City of West Linn
PRE-APPLICATION CONFERENCE MEETING
Notes
November 21, 2013

SUBJECT: Planned Unit Development and Class II Design Review for duplex-style multi-family development, possibly requiring Water Resource Area permit, at 18270/18340 Willamette Drive and 18395 Shady Hollow Way. Water Resource Area (WRA) approval also applies unless professional analysis proves there is no actual open drainage channel.

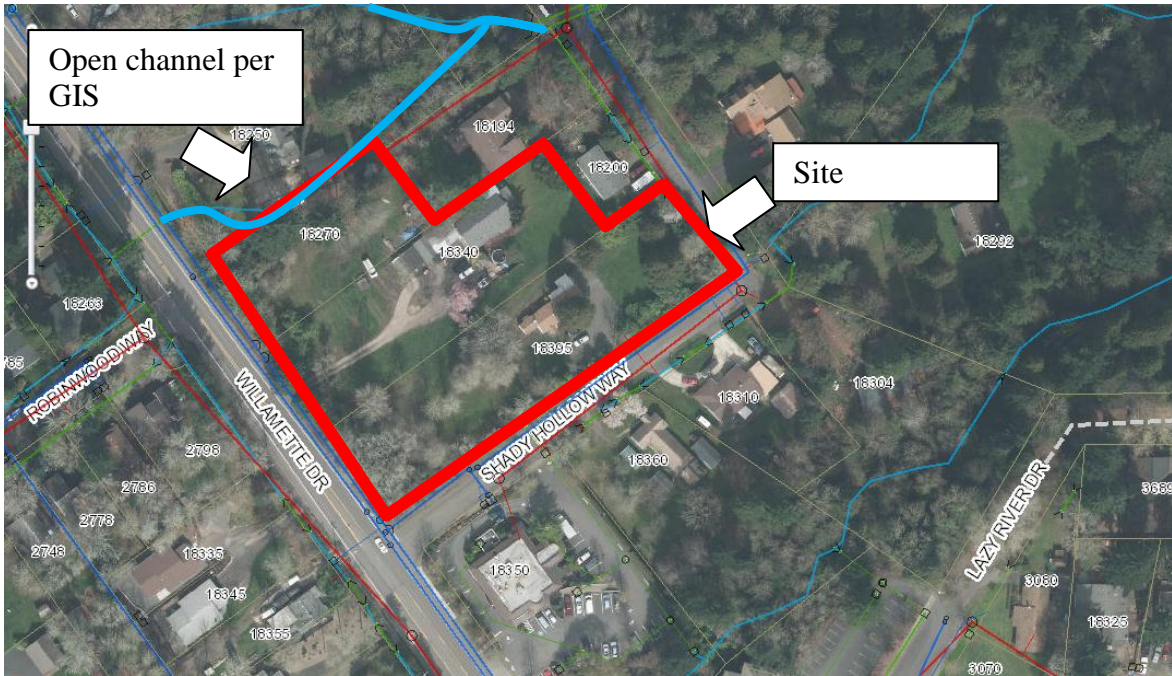
The zone change approval from 2008 which changed the site from R-10 to R-4.5 came with conditions, which are listed in the zone change ordinance for the site. The file is ZC-08-01/PLN-08-06. Condition of Approval 3 in the ordinance requires a 25-foot –wide buffer between buildings on the site and the properties to the east. The concept plan will have to be modified to meet this standard, even if units are lost.
